ROOSEVELT ELEMENTARY SCHOOL MODERNIZATION

2324 VERDE STREET
FOR
BAKERSFIELD CITY SCHOOL DISTRICT
BAKERSFIELD, KERN COUNTY, CALIFORNIA

TITLE SHEET, SHEET INDEX & VICINITY MAP

FLOOR PLAN
BUILDING 'A',
PARTIAL FLOOR
PLAN & DEMO
FLOOR PLAN

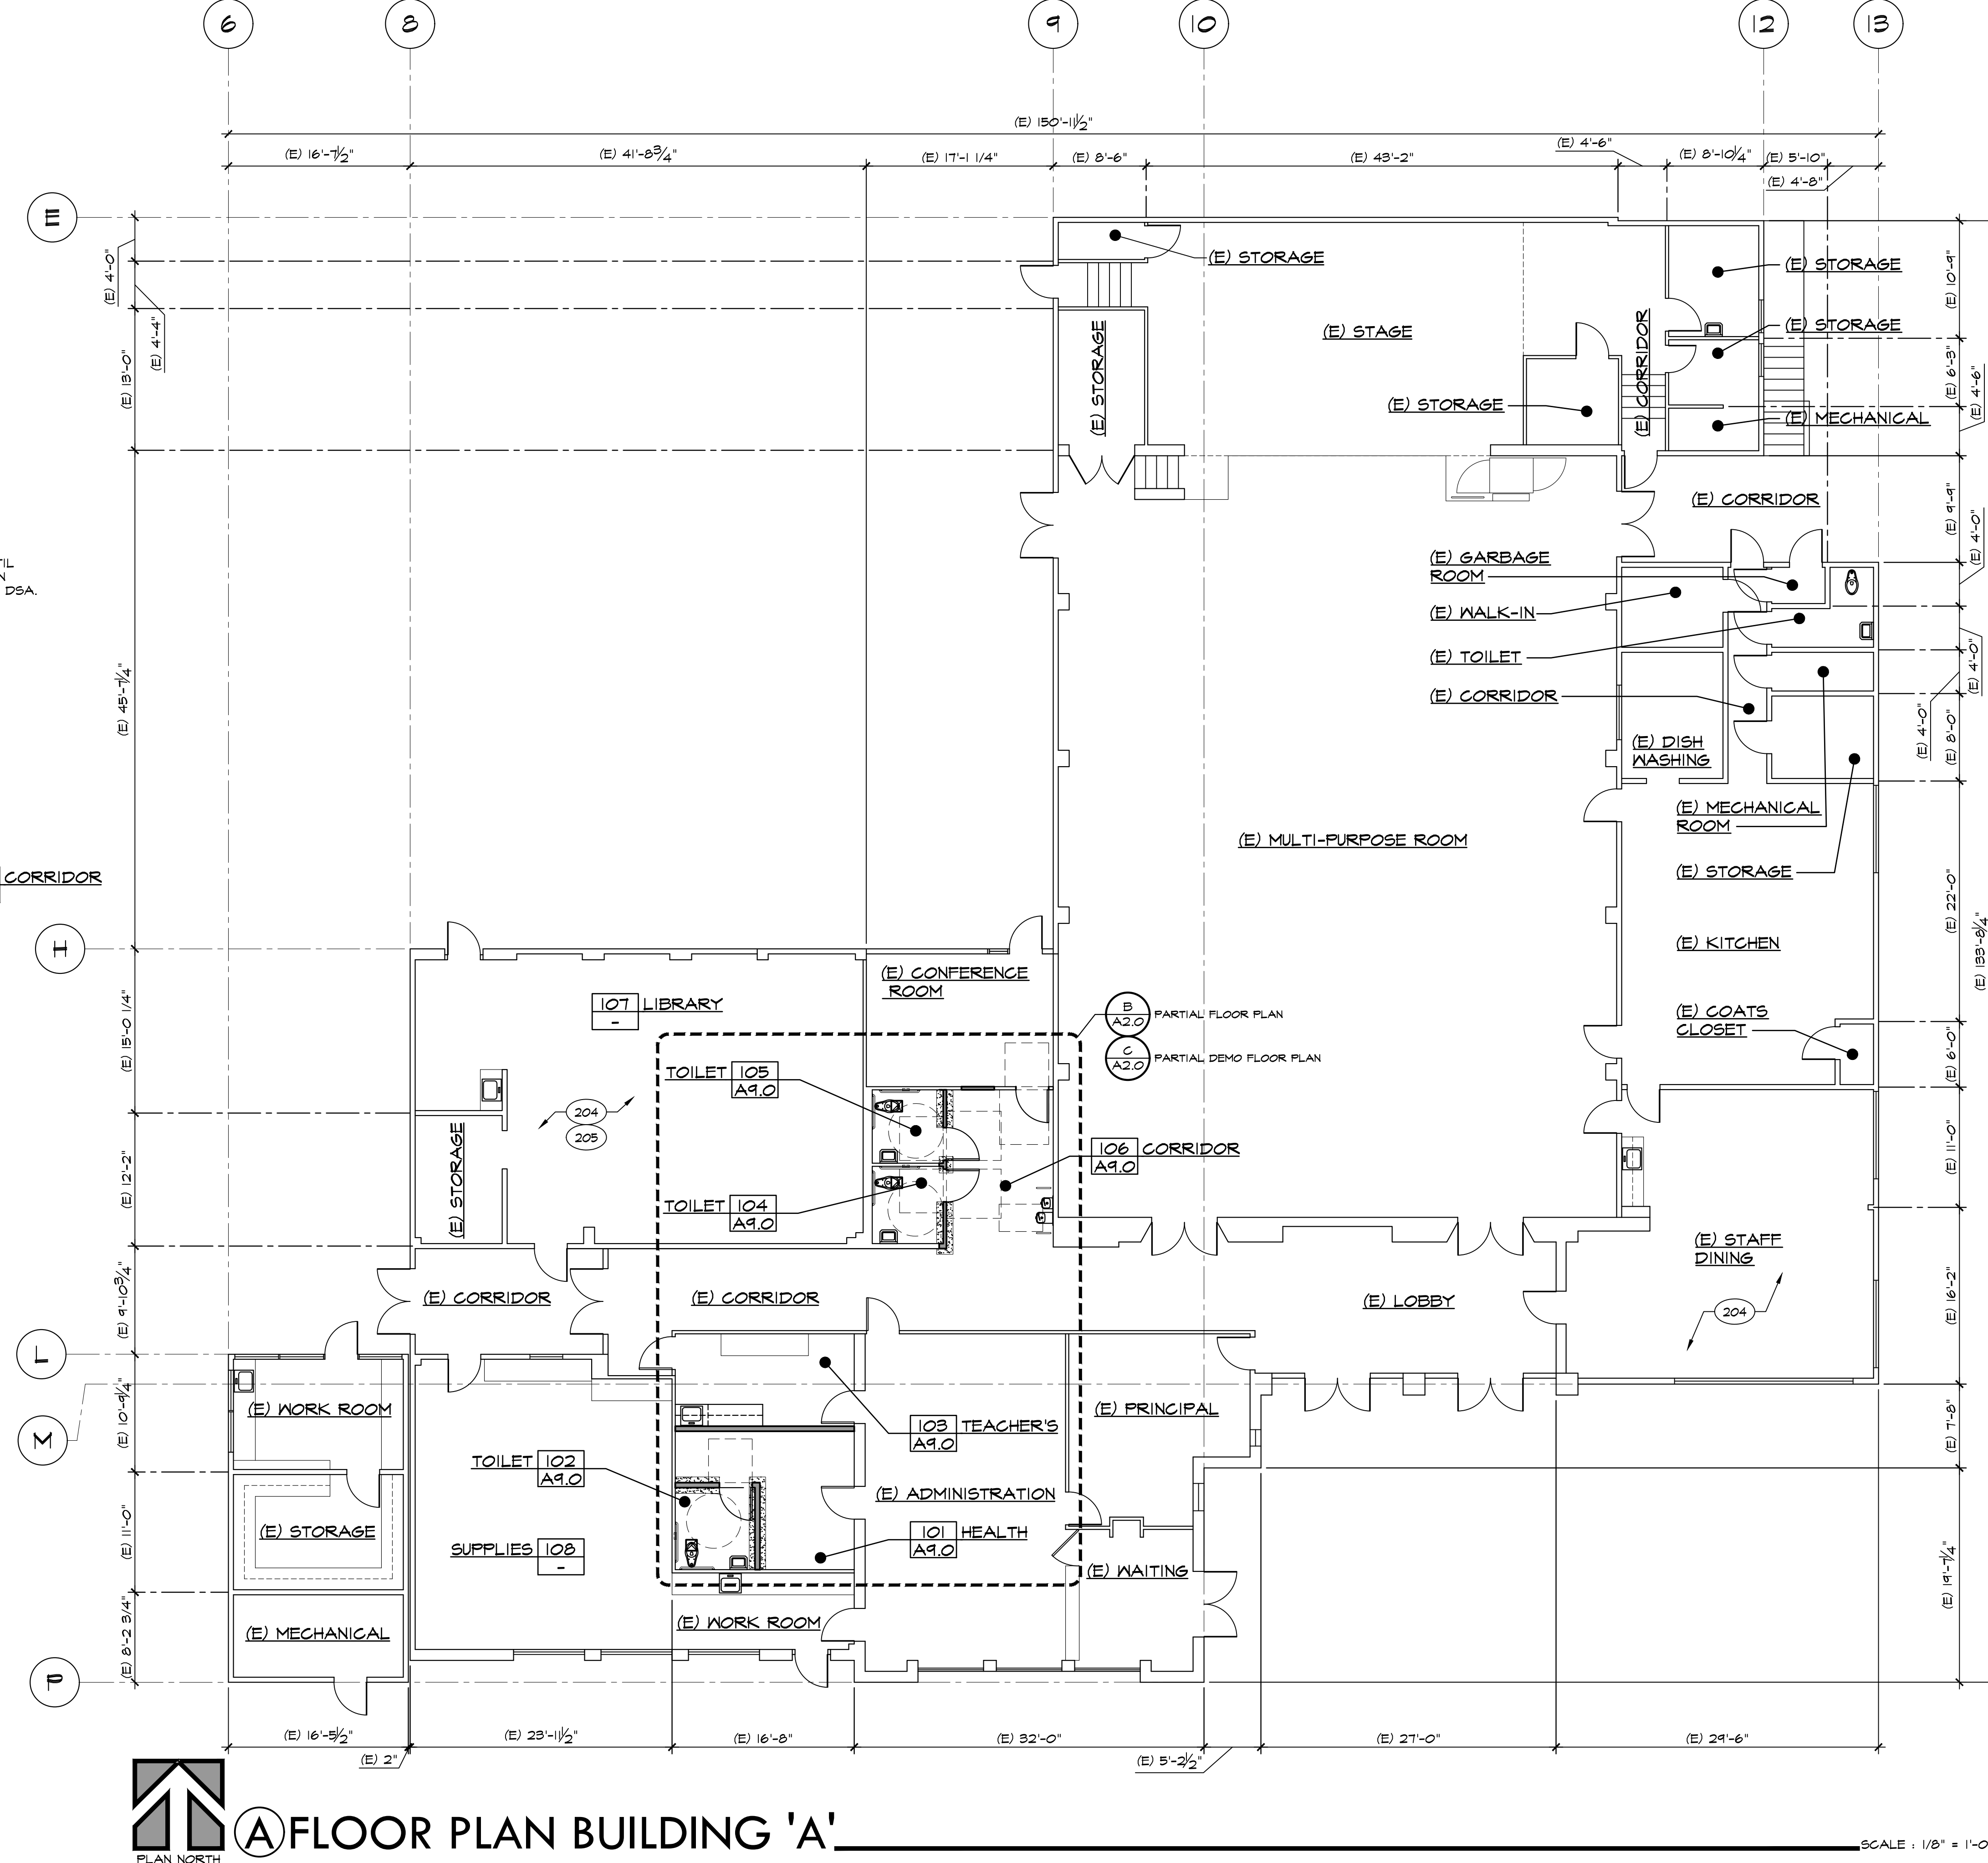
DIV 09: (VER) - Plans lack details for selective demolition and patching required for new plumbing fixture locations in restrooms.

FLOOR PLAN
BUILDING 'B',
PARTIAL FLOOR
PLAN & DEMO
FLOOR PLAN

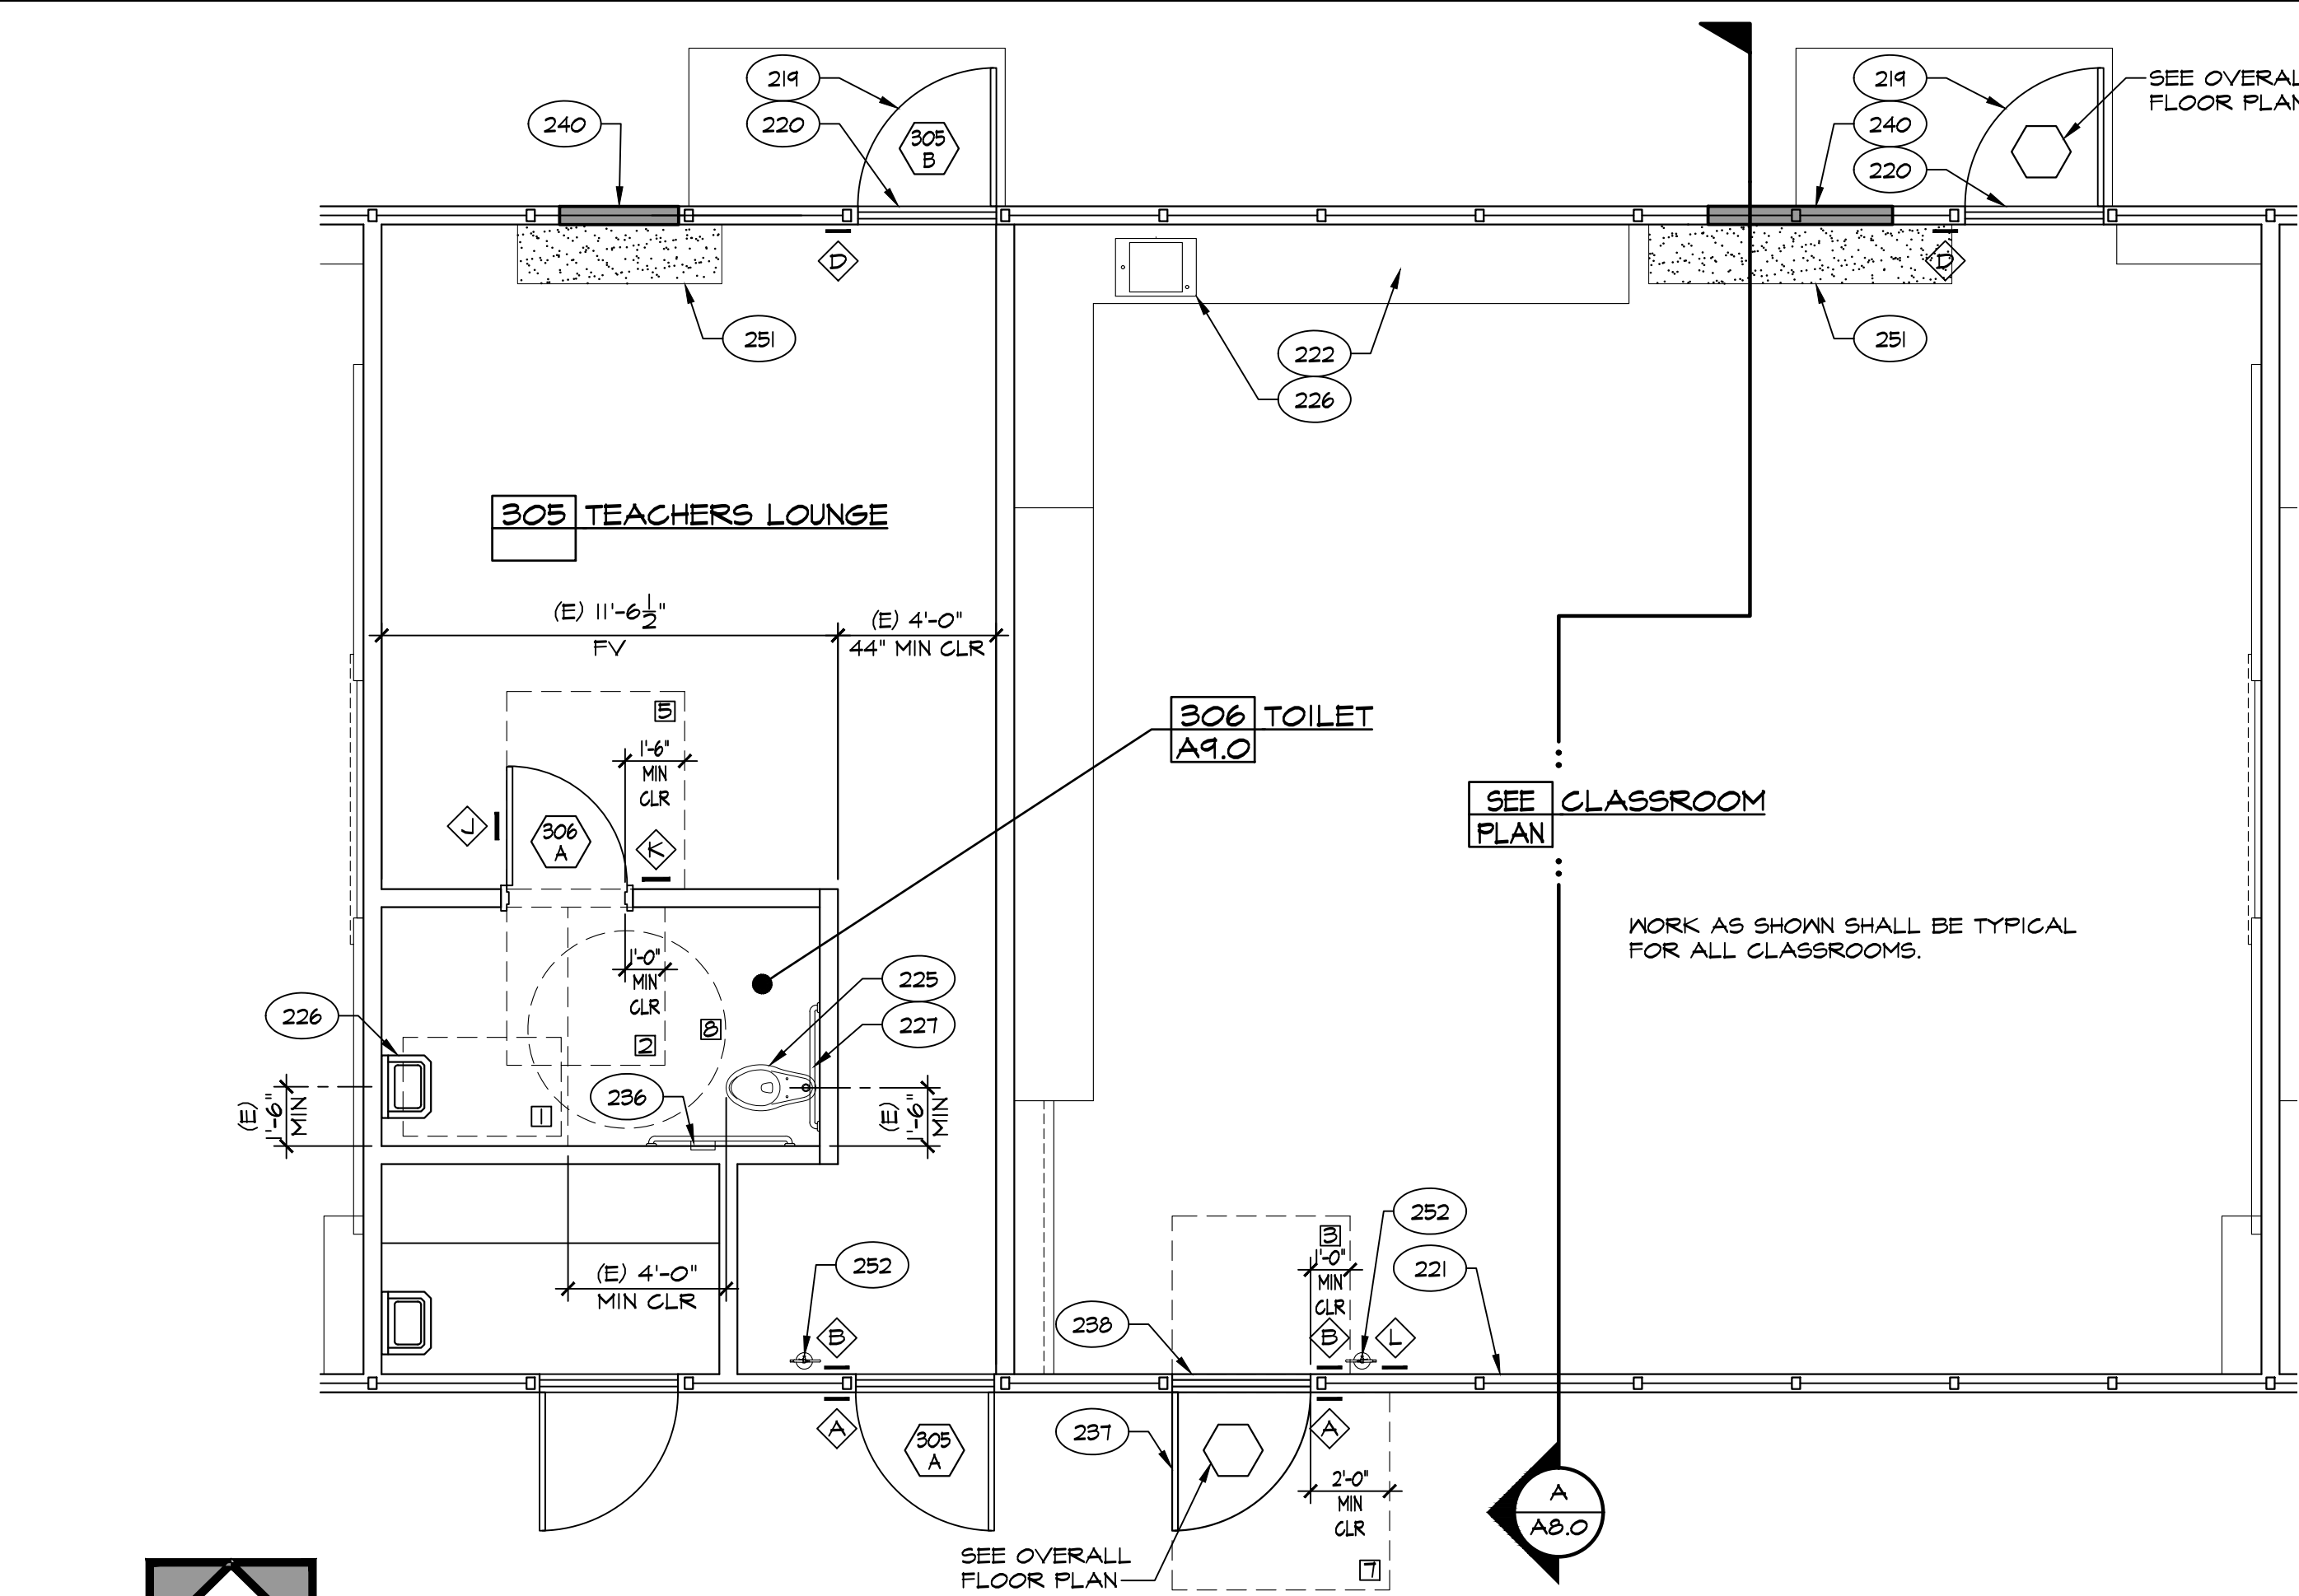
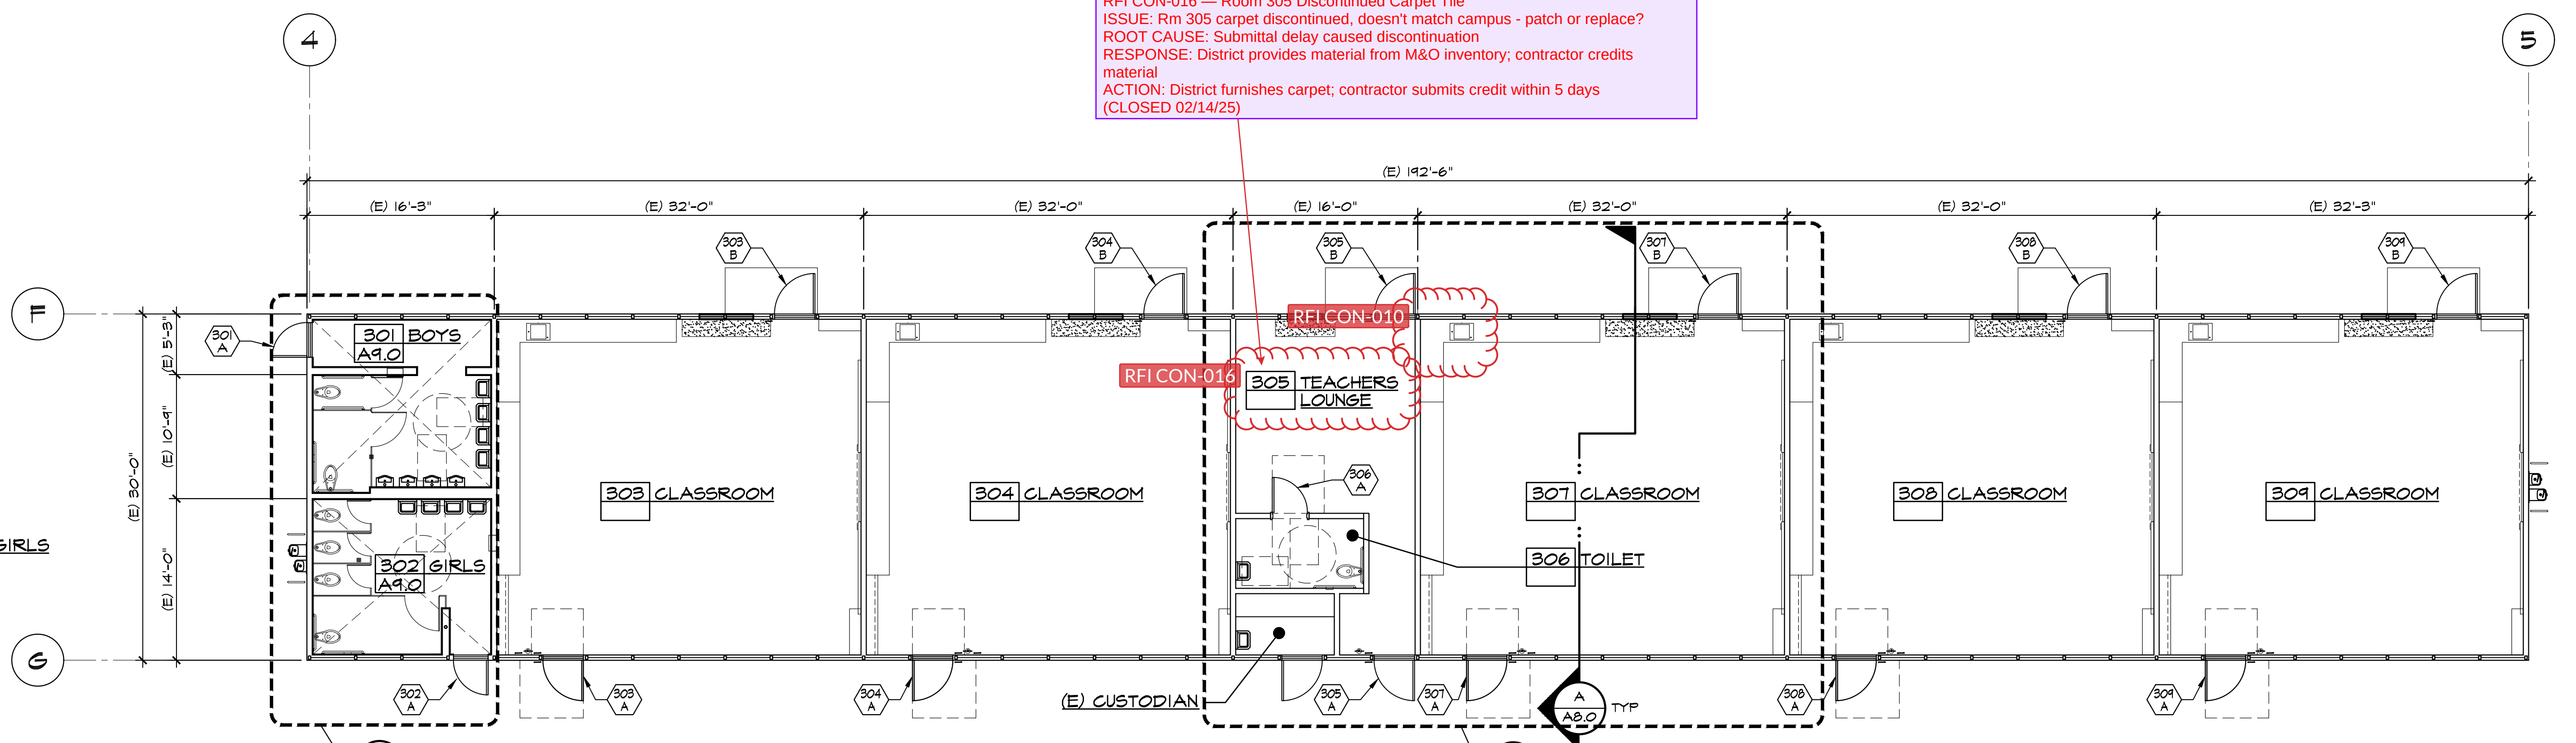
RFI CON-016 — Room 305 Discontinued Carpet Tile
ISSUE: Rm 305 carpet discontinued, doesn't match campus - patch or replace?
ROOT CAUSE: Submittal delay caused discontinuation
RESPONSE: District provides material from M&O inventory; contractor credits material
ACTION: District furnishes carpet; contractor submits credit within 5 days (CLOSED 02/14/25)
